Planning Committee

Edinburgh BioQuarter and South East Wedge Parkland: Finalised Masterplan

Item number	7.1
Report number	
Executive/routine	Executive
Wards	Ward 16- Liberton /Gilmerton Ward 17-Portobello/Craigmillar

Appendix 1: Responses received on the non-statutory masterplan for the Edinburgh BioQuarter and the South East Wedge (SEW) Parkland.

Key Diagram

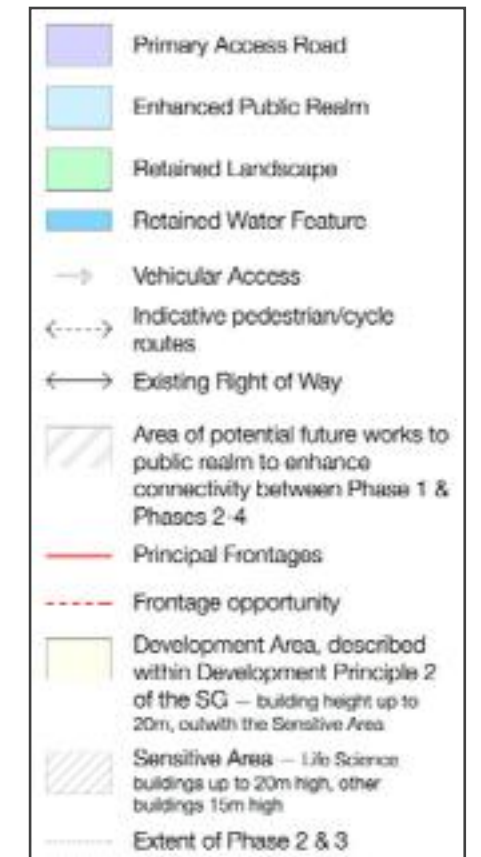
Scotways (Scottish Rights of Way Society) expressed concern that two rights of way (LC90/LC91) have not been identified. The masterplan has now been amended to show these rights of way.

Scotways	<ul style="list-style-type: none"> • Two rights of way (LC90 / LC91) Concerned that neither of the rights of way appear on key diagram (p.6). Both routes should be clearly marked on Masterplan. Continuing access should be permitted during construction , even if temporary diversions are required for safety or practical reasons. While LC90 follows the line of a public road, the key diagram marks it for traffic coming from New Greendykes as ‘public transport vehicles’ only, which seems to preclude other public access. Post construction works, this route should be signposted to confirm that cyclists are also permitted to use it. While other pedestrian cycle routes are indicated on diagram, they do not appear to provide access to the same areas as the rights of way. • CEC response to earlier comments about LC90 was that the location of the footpaths was dealt with in the key diagram of the draft NS Masterplan, but neither right of way is marked. The draft Masterplan refers to a cycle route connecting Craigmillar Castle Road and Greendykes Road with the Wisp, the 	<p>Rights of Way (LC90/LC91) have been marked on the key diagram (page 6 of the masterplan).</p> <p>As above.</p>

<p>Scottish Natural Heritage</p>	<ul style="list-style-type: none"> • The key diagram on page 6 does not appear to reflect the full extent of proposed development as portrayed elsewhere within the draft masterplan document . SUDS will constitute development and the SUDS strategy diagram shows proposals for off-site features of an uncertain scale or form. SNH have concerns that the SUDS requirements could be extensive and may adversely affect the size and quality of the park and the wider active travel provision that it will provide. • Suggest that a precise boundary is drawn to the developable area and that the form and function of land use proposals is suitably colour coded. • Concerned that the draft Masterplan shows the proposed ‘frontage opportunity’ in a location some 50m further north than shown in the SG. • Support use of term ‘key building project’ rather than ‘frontage opportunity’. However, have concerns that the draft masterplan does not set out clearly how built form, streets and associated green infrastructure should come together to address this key aspect of the site’s landscape setting. Suggest that further information illustrating the outline requirements for the delivery of a well designed frontage should be portrayed by masterplan including building heights and profile, spacing between blocks, connectivity and scale and the location and nature of proposed landscape treatment. 	<p>The technical information provided in the masterplan read in conjunction with the finalised SG(1.b to k) and CEC’s Flood Prevention Guidance contain sufficient information to inform the basis of a strategic flood risk management framework for the site. All future planning applications should accord with the principles contained within these documents.</p> <p>Not agreed. A precise boundary highlighting the developable area with colour coding to indicate the form and function of land use proposals would be too prescriptive at this masterplan stage.</p> <p>The boundaries shown in the SG are diagrammatic. The frontage line shown on the digitised version of the LDP is the statutory boundary and this is the line which any applications will be assessed against. The building line shown on the masterplan coincides with the LDP.</p> <p>Not agreed. It would be inappropriate to include this level of detail at the masterplan stage. The necessary parameters of development are incorporated and sufficient flexibility is preferred for assessment of details at the planning application stage.</p>
